PREPARED FOR MDC HOLDINGS RICHMOND AMERICAN HOMES 4350 S. MONACO STREET DENVER, CO 80237 ATTN: JASON POKK 720-977-3827	JR ENGINEERING A Verticon Company Centennial 303-740-9363 • Colorado Springs 719-589-2883 Fort Collins 970-491-9988 • www.jrengineering.com	H-SCALE 1" = 30' V-SCALE 1" = 5' DATE 10-30-20 DESIGNED BY APL DRAWN BY APL CHECKED BY
		URBAN COLLECTION AT PALMER VILLAGE WATER DISTRIBUTION PLAN WATER SYSTEM PLAN
SHEET 4 OF 10 JOB NO. 25149.01

URBAN COLLECTION AT PALMER VILLAGE
WATER DISTRIBUTION PLAN
WATER SYSTEM PLAN

WPO2 CROSSINGS 2 & 3 PROFILE
STA 6+00.00 TO 6+65.00

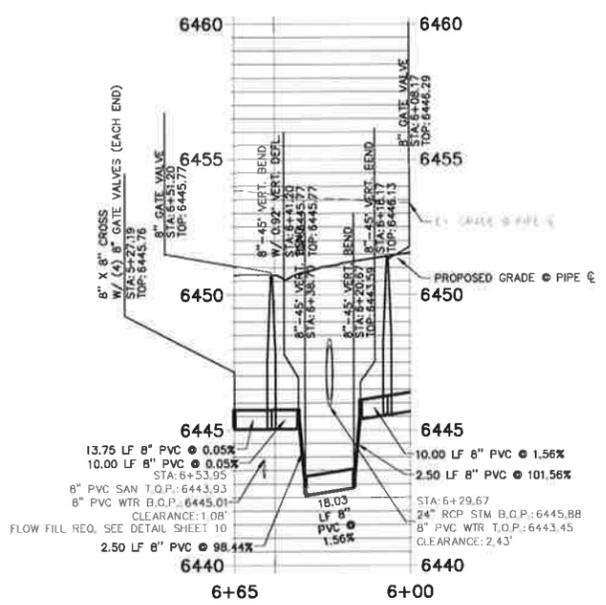
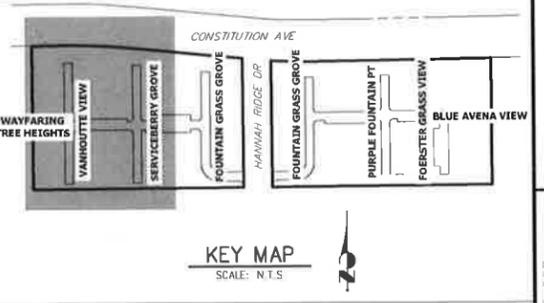
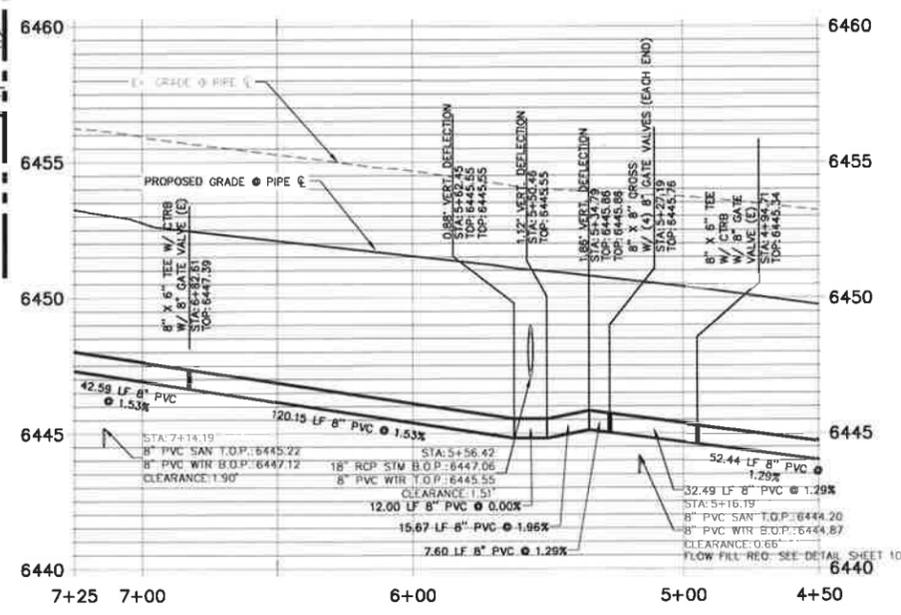
ADD VALVE

ADD VALVE
